**PROJECT SPECIFIC PLAN FOR EXCAVATION CONTROL  
OF AREAS 3B, 4B, AND 5  
(SUPPLEMENT TO 20300-PSP-0011)**

**FERNALD CLOSURE PROJECT  
FERNALD, OHIO**

**20810-PSP-0006  
REVISION 1  
FINAL**

As noted in the above paragraph, excavation in Area 3B and Area 4B has commenced. All variances documenting the work in these areas, issued under the Project Specific Plan for Area 3A/4A Excavation Characterization and Precertification, 20200-PSP-0009, are attached as Appendix A.

FIGURE 1. LOCATION OF WAC VERIFICATION SAMPLING AREA

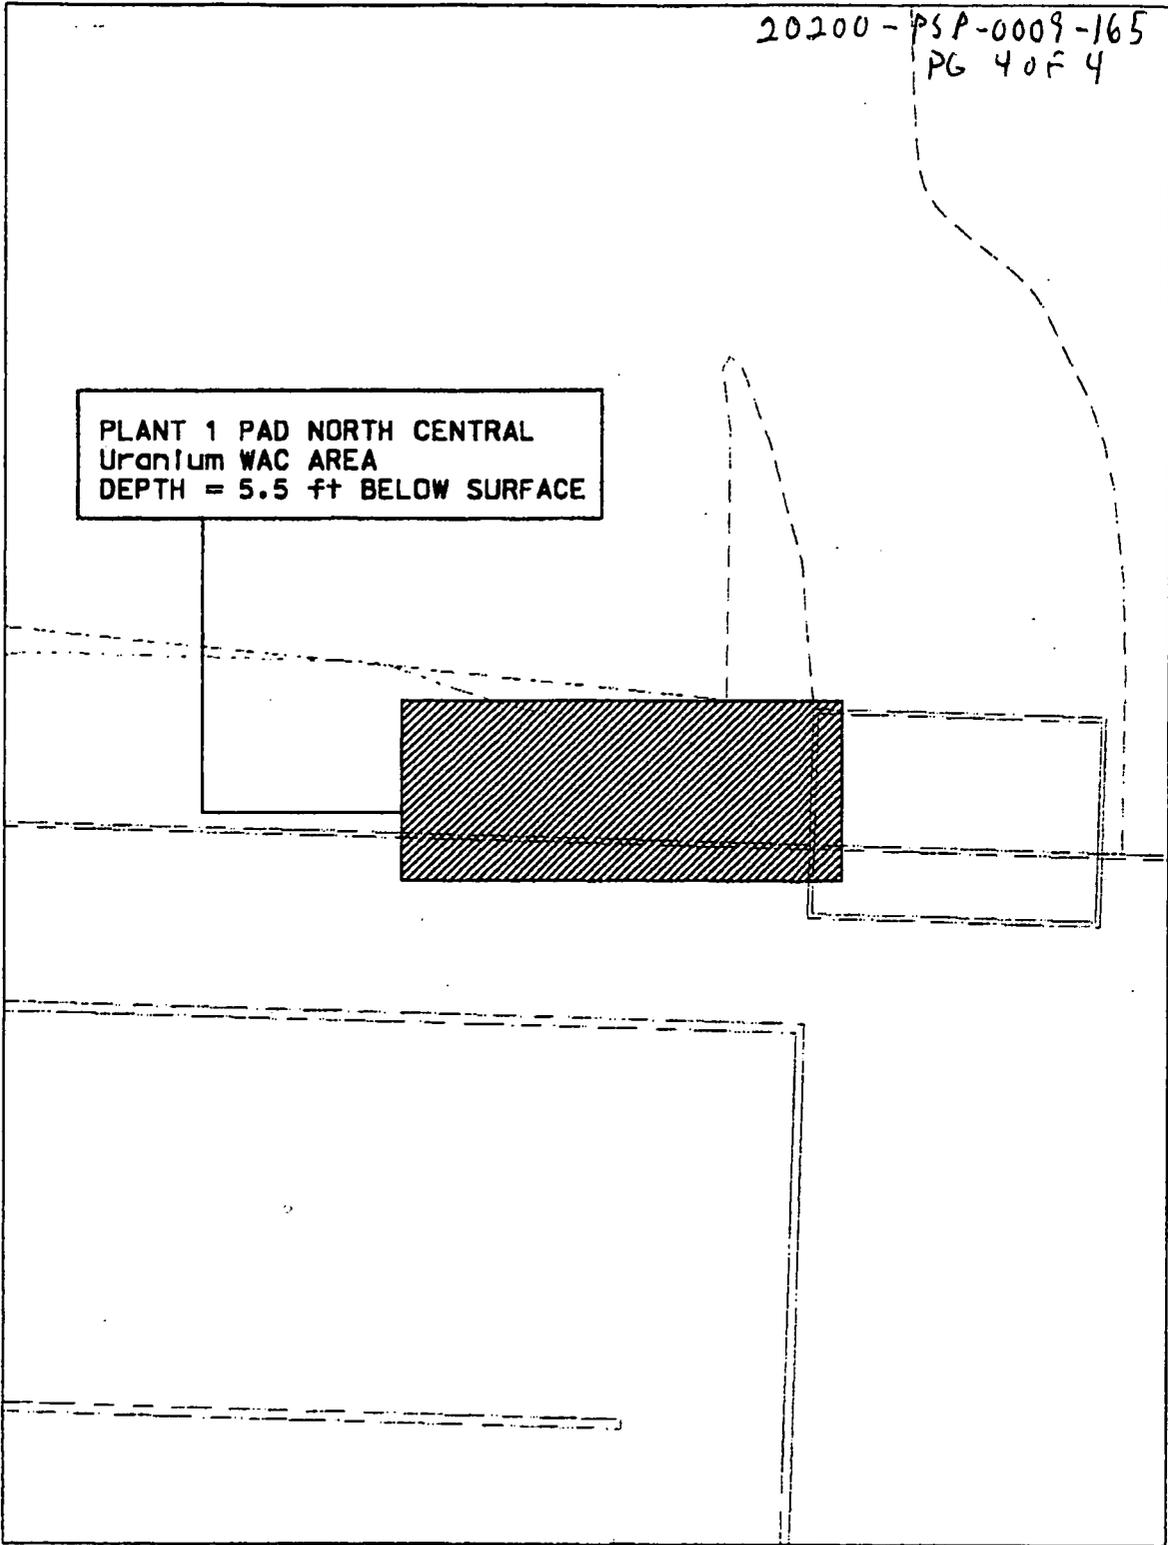
This Variance/Field Change Notice (V/FCN) documents the collection of grab soil samples to replace the real-time scanning requirements in Area 3B from the Plant 1 Pad - North Central (AWAC area 5) area for total uranium. This particular above-WAC area is not in the 3A/4A scope. A formal PSP to describe the remainder of Area 3B is in process and will be submitted in the near future. Samples are to be collected in the above-WAC total uranium area that has been excavated to design grade to verify above-WAC total uranium has been removed, see Figure 1. This area is approximately 20' by 40'. Coordinate with the Construction Lead and/or WAO Representative for this sampling event.

This V/FCN requests the collection of grab soil samples to verify removal of above-WAC total uranium in Area 3B Plant 1 Pad-NC to replace the real-time scanning requirements. Ohio EPA approves this variance.

FIGURE 1. LOCATION OF WAC VERIFICATION SAMPLING AREA

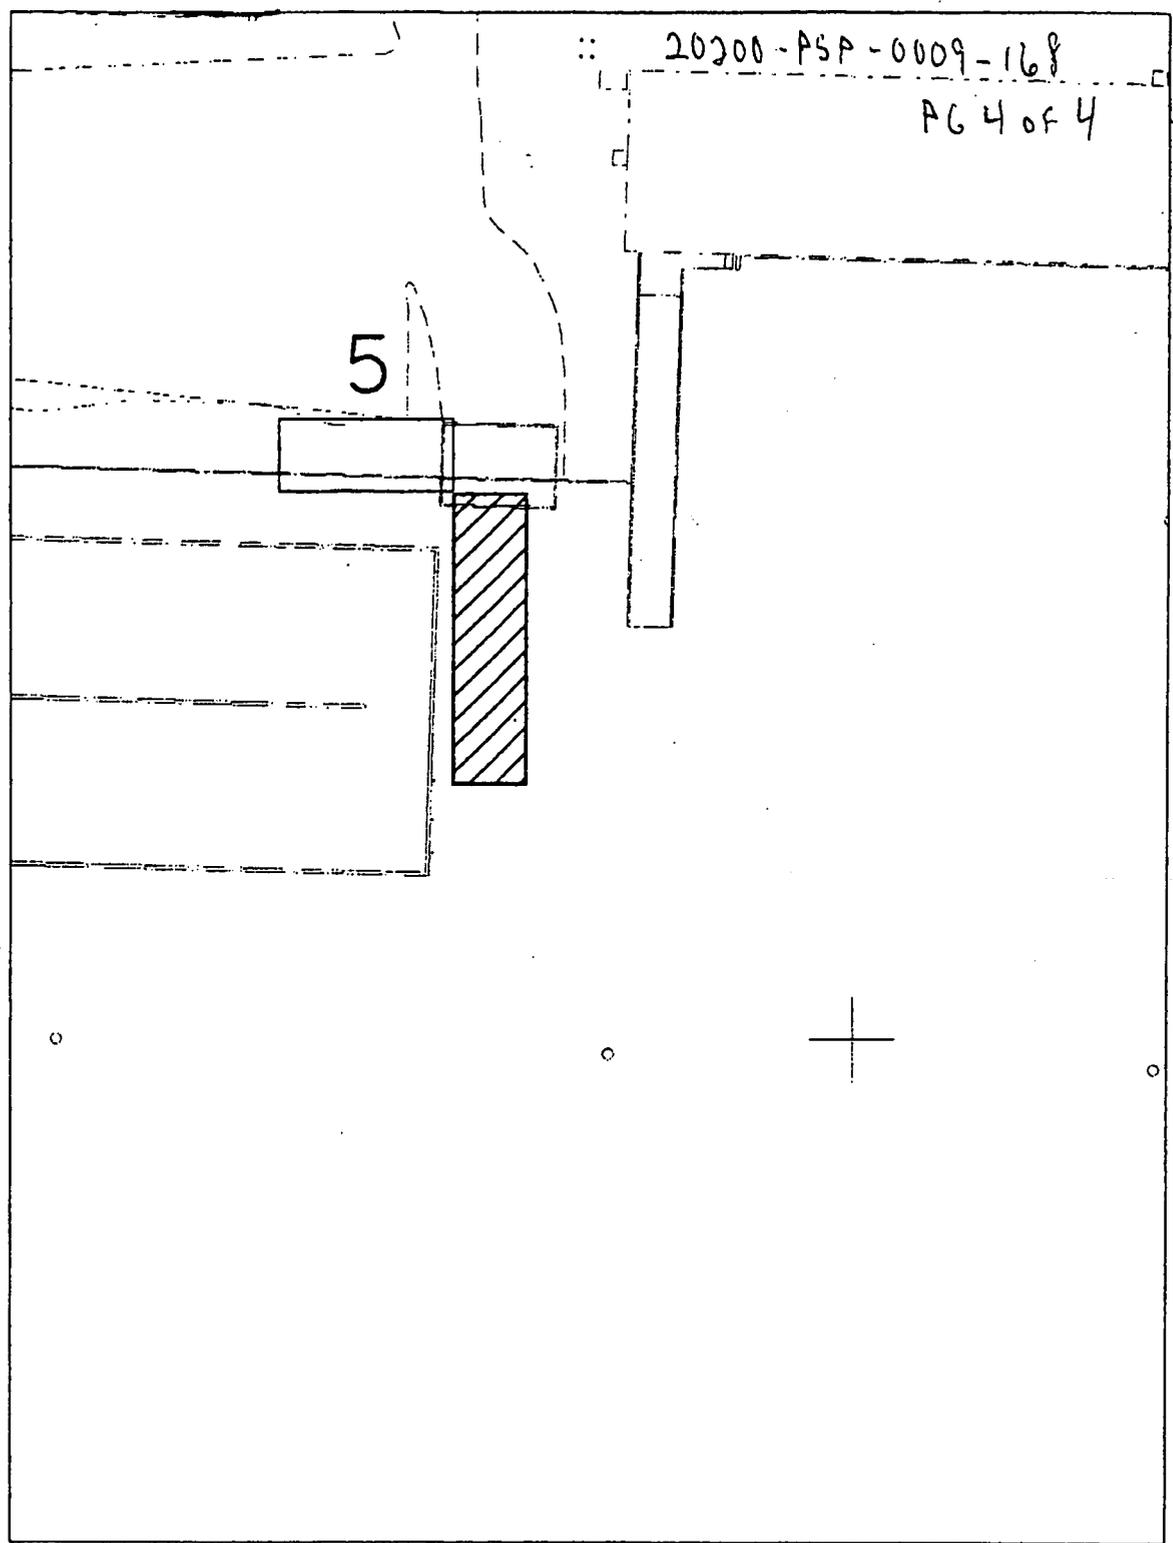
This Variance/Field Change Notice (V/FCN) documents the collection of grab soil samples in north central area of Area 3B (see Figure 1) for technetium-99 and total uranium. The specific area contains a drainage line from the AWAC Stockpile (formerly SP7), which was broken during excavation. This potential AWAC area is not in the 3A/4A scope. A formal PSP to describe the remainder of Area 3B is in process and will be submitted in the near future. Samples are to be collected to determine if the soil is above-WAC for technetium-99 and/or total uranium. This area is approximately 20' by 80.' The water that escaped the pipe seeped into approximately 40 feet of the bottom soil in the area. Coordinate with the Construction Lead and/or WAO Representative for this sampling event.

The intention of this variance is to determine whether or not elevated levels of total uranium and/or technetium-99 exist in the sidewalls of the excavated area that contains the former SP7 drainage line. The line itself needs to remain in use for an extended period of time. The line and soils immediately beneath the line will be investigated once the line is no longer needed. However, additional excavations are planned in the area adjacent to this excavated area, and the determination of whether or not uranium and/or technetium-99 is now a concern in these future excavations needs to be made at this time. If elevated levels of uranium and/or technetium-99 exist in the sidewalls of the excavated area that contains the former SP7 drainage line, then additional sampling would be necessary to bound the lateral extent of the uranium and/or technetium-99 contamination.

As stated in the variance, the bottom of the area is covered with two to three feet of crushed concrete; therefore, samples from the bottom of the area will not be collected at this time. The final excavation of the former SP7 drainage line is planned in 2005. At that time, samples will be collected from the bottom of this excavated area and additional excavations will be performed as necessary based on the results of those samples.

FIGURE 1. LOCATION OF REALTIME REPLACEMENT SAMPLING AREA

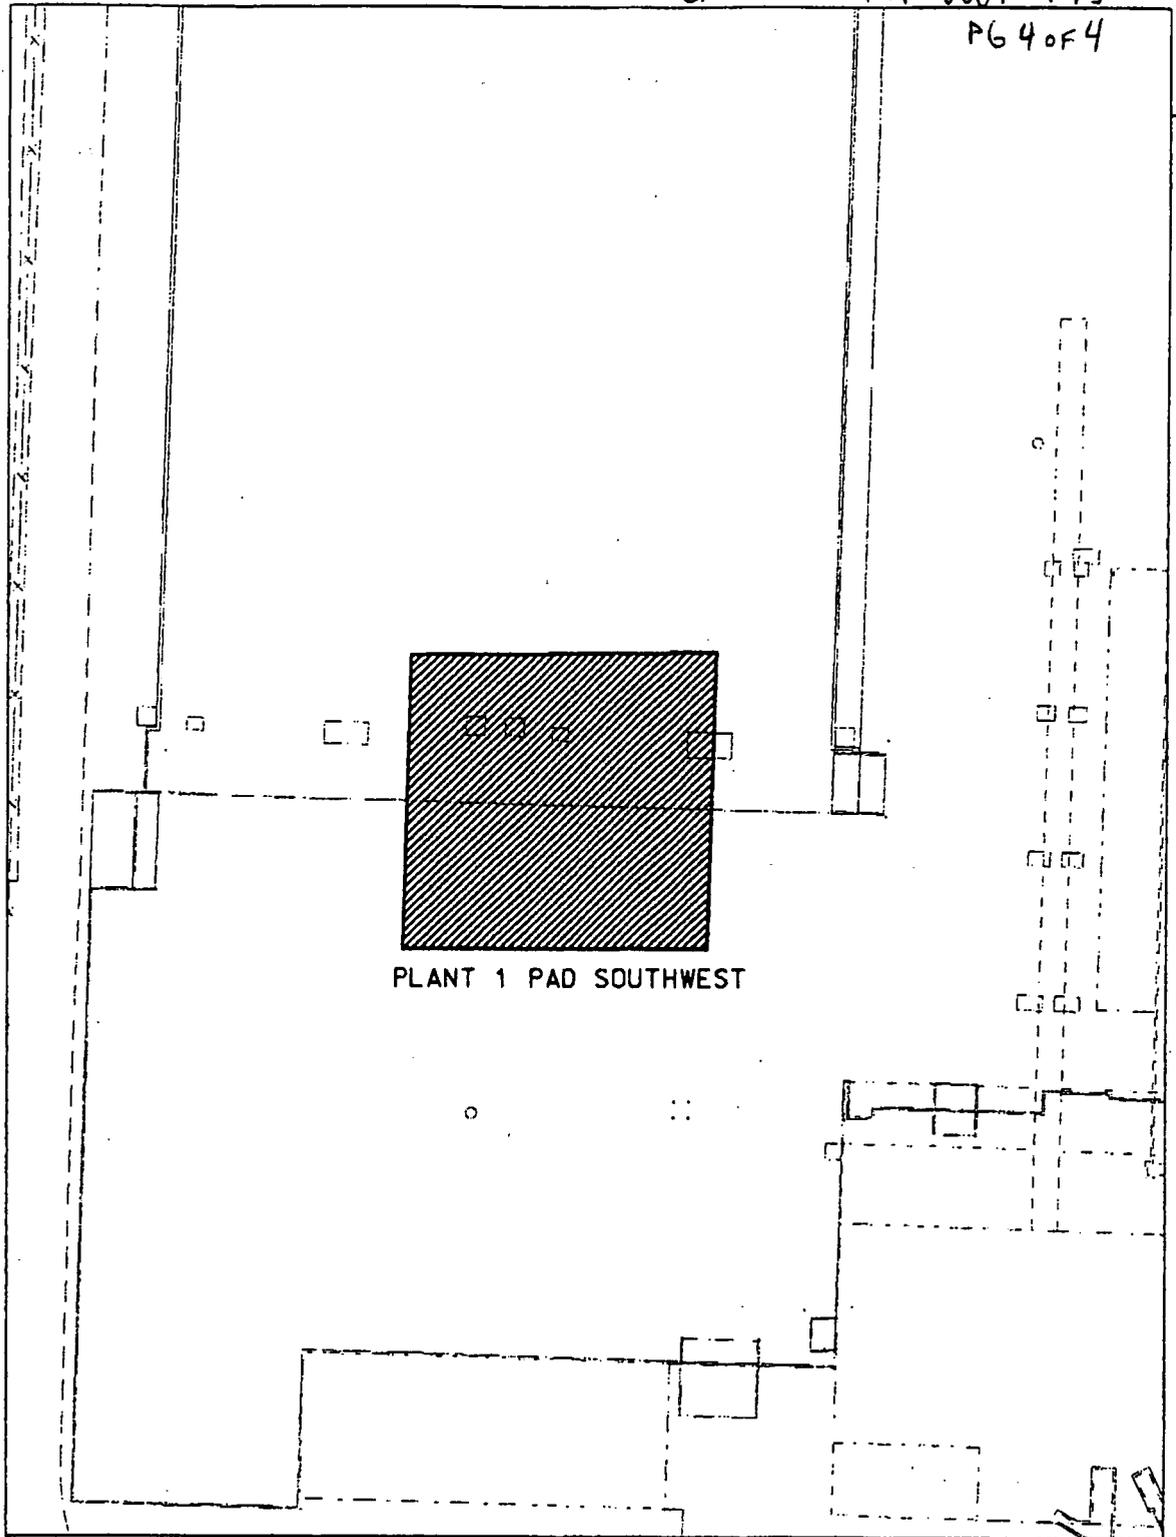
This Variance/Field Change Notice (V/FCN) documents the collection of grab soil samples to replace the real-time scanning requirements in Area 3B for total uranium. The area is located on the western side of Area 3B (see Figure 1). This particular area is not in the 3A/4A scope. A formal PSP to describe the remainder of Area 3B is in process and will be submitted in the near future. Surface samples are to be collected from the floor and sidewalls of lift 3 of this area to support the lift scan requirements for this lift. This area is approximately 85' by 85'. Coordinate with the Construction Lead and/or WAO Representative for this sampling event.

This V/FCN documents the collection of grab soil samples in Area 3B from the Plant 1 Pad-Southwest Area for total uranium in lieu of real-time scanning. Ohio EPA approves this variance.

FIGURE 1. LOCATION OF WAC VERIFICATION SAMPLING AREA

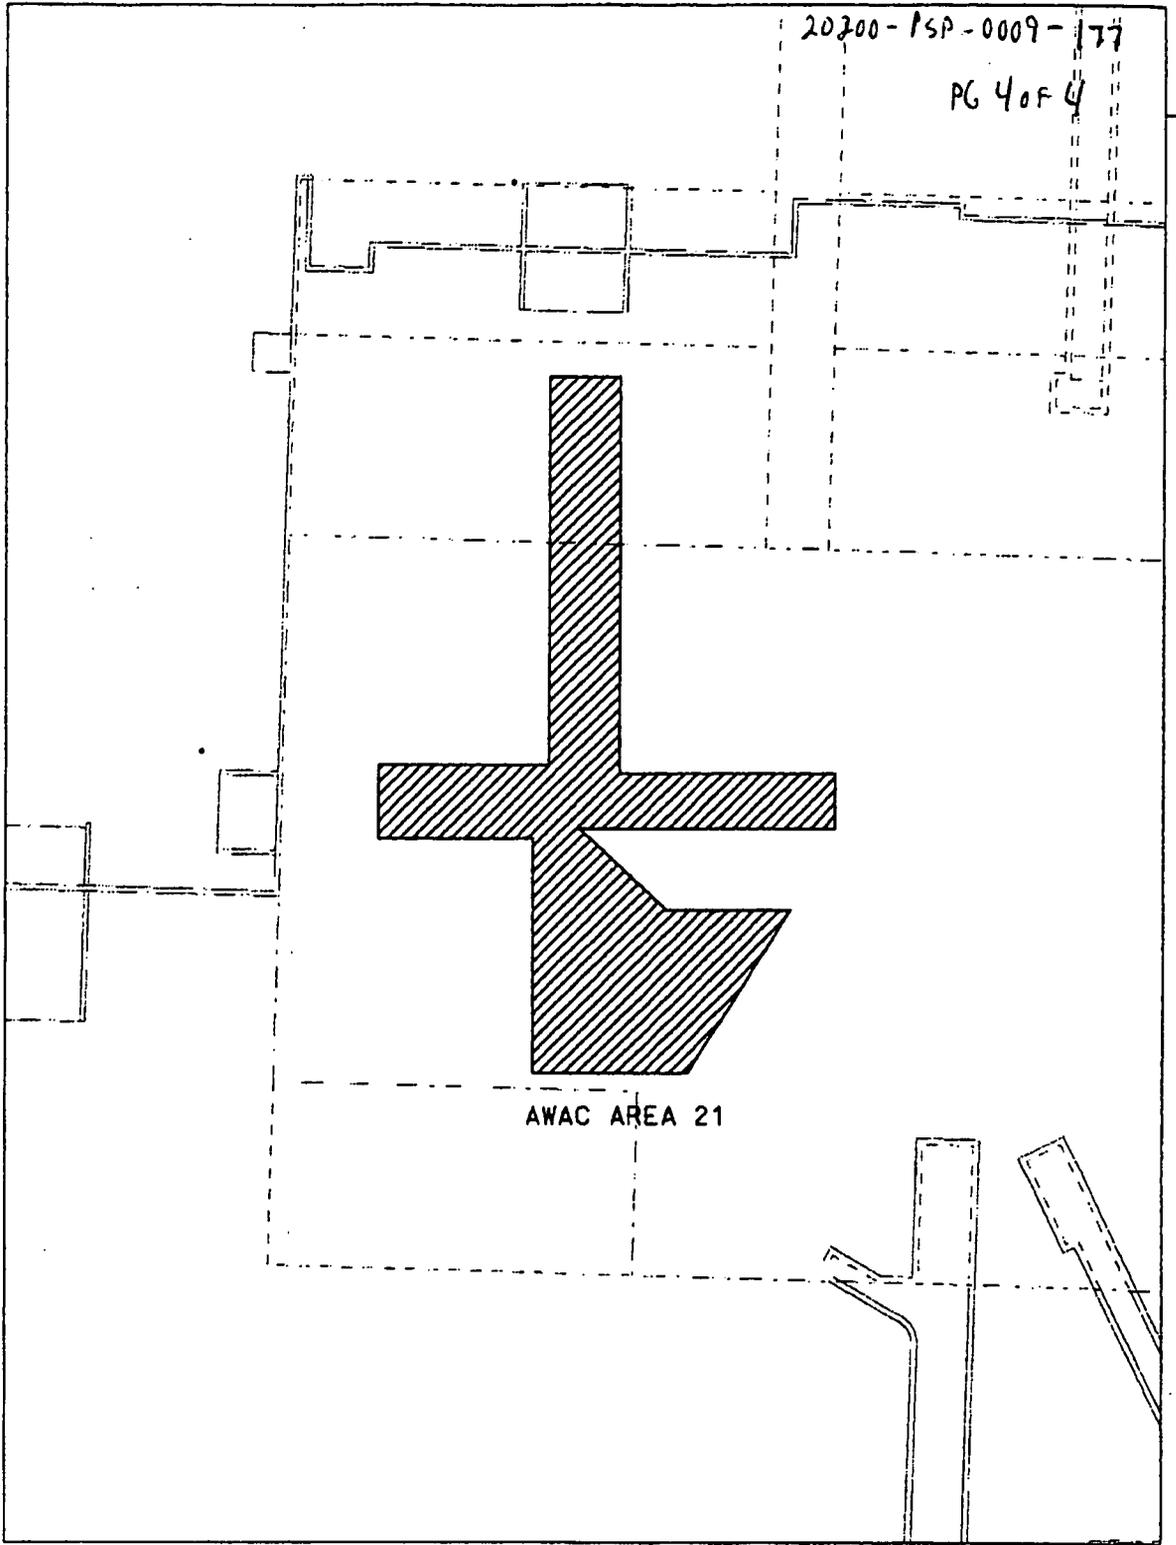
This Variance/Field Change Notice (V/FCN) documents the collection of grab soil samples to replace the real-time scanning requirements in Area 3B from Plant 1 (AWAC area #21) area for total uranium. This particular above-WAC area is not in the 3A/4A scope. A formal PSP to describe the remainder of Area 3B is in process and will be submitted in the near future. Samples are to be collected in the above-WAC total uranium area that has been partially excavated. During excavation, piping was struck and broken. The piping contained black material that is suspected to be uranium oxide (black oxide). This area is approximately 4' by 200'. Coordinate with the Construction Lead and/or WAO Representative for this sampling event.

This VIFCN documents the collection of grab soil samples in the southwest Area 3B from an above-WAC Area (AWAC area 21) for total uranium in lieu of the real time scanning. While excavating in this area, a pipe containing what is suspected to be uranium oxide was struck and broken. Ohio EPA approves this variance.

FIGURE 1. LOCATION OF SUMP

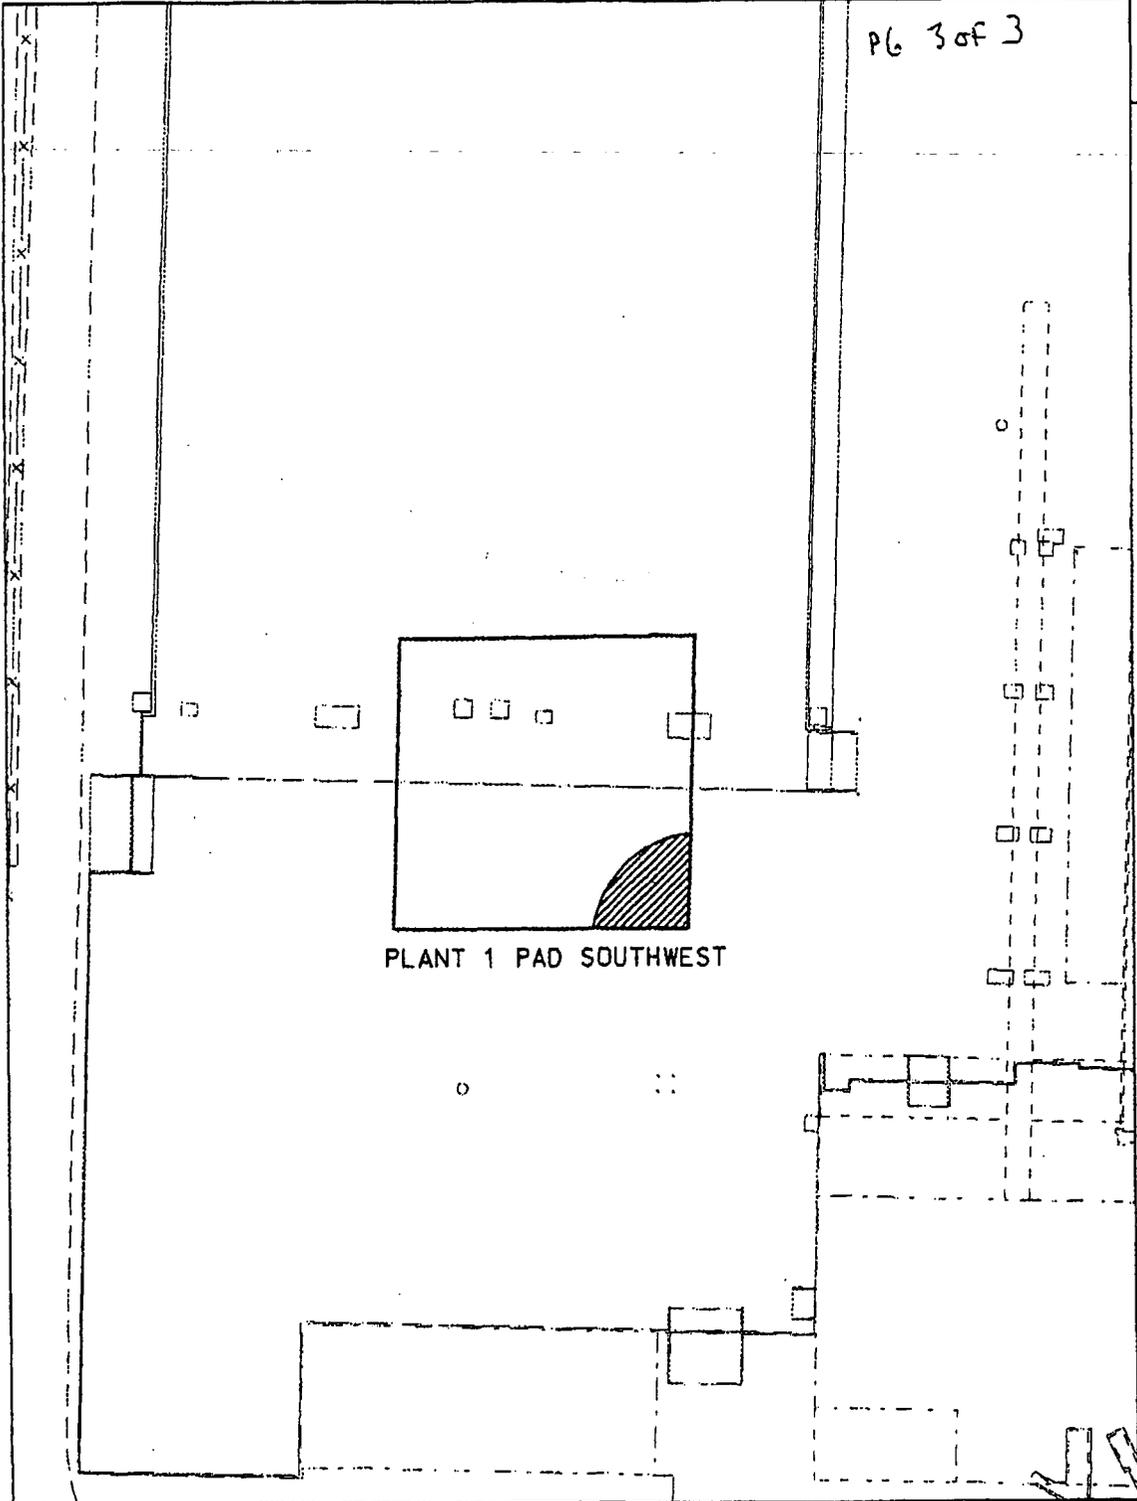
This Variance/Field Change Notice (V/FCN) documents the collection of a grab water sample in Area 3B for total uranium (TAL U). The area is located on the western side of Area 3B (see Figure 1). This particular area is not in the 3A/4A scope. A formal PSP to describe the remainder of Area 3B is in process and will be submitted in the near future. This excavated area, which is approximately 12 feet deep, has water seeping into it from the sidewalls. The sample should be collected from the "sump" area on the eastern side of the excavation. Coordinate with the Construction Lead and/or WAO Representative for this sampling event.
